TRANS/WP.29/2005/84
28 July 2005

PROPOSAL FOR CORRIGENDUM 3 TO THE 06 SERIES OF AMENDMENTS
TO REGULATION No. 14

(Safety-belt anchorages)

Transmitted by Working Party on Passive Safety (GRSP)

Figure 7: ISOFIX Top tether anchorage location, ISOFIX zone - Enlarged side view of wrap-around area "

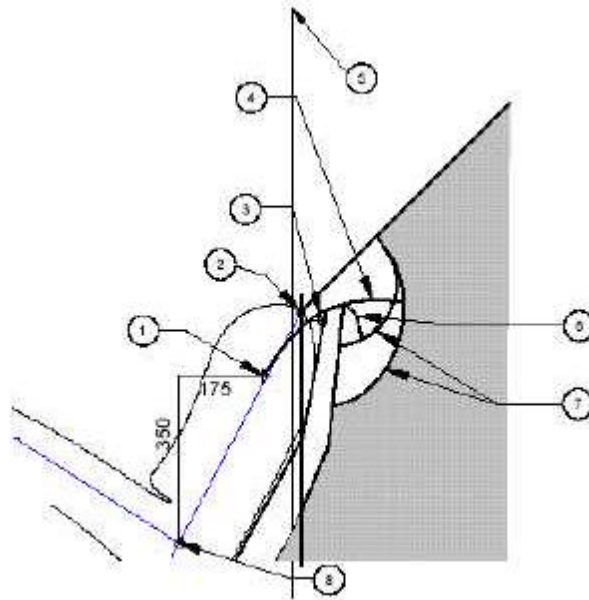
Annex 9, Figure 7, amend to read:

- 1 "V" point
- 2 "R" point
- 3 "W" point
- 4 Strap wrap-around length from "V" point: 250 mm
- 5 Vertical longitudinal plane
- 6 Strap wrap-around length from "W" point: 200 mm
- 7 Arcs created by wrap-around lengths
- 8 H-point

NOTE 1 Portion of top tether anchorage that is designed to bind with the top tether hook to be located within shaded zone

NOTE 2 "R" point: Shoulder reference point

NOTE 3 "V" point: V-reference point, 350 mm vertically above and 175 mm horizontally back from H-point

NOTE 4 "W" point: W-reference point, 50 mm vertically below and 50 mm horizontally back from "R" point

NOTE 5 "M" plane: M-reference plane, 1000 mm horizontally back from "R" point

NOTE 6 The forwardmost surfaces of the zone are generated by sweeping the two wraparound lines throughout their extended range in the front part of the zone. The wraparound lines represent the minimum adjusted length of typical top tether straps extending from either the top of the CRS (W-point), or lower on the back of the CRS (V-point).
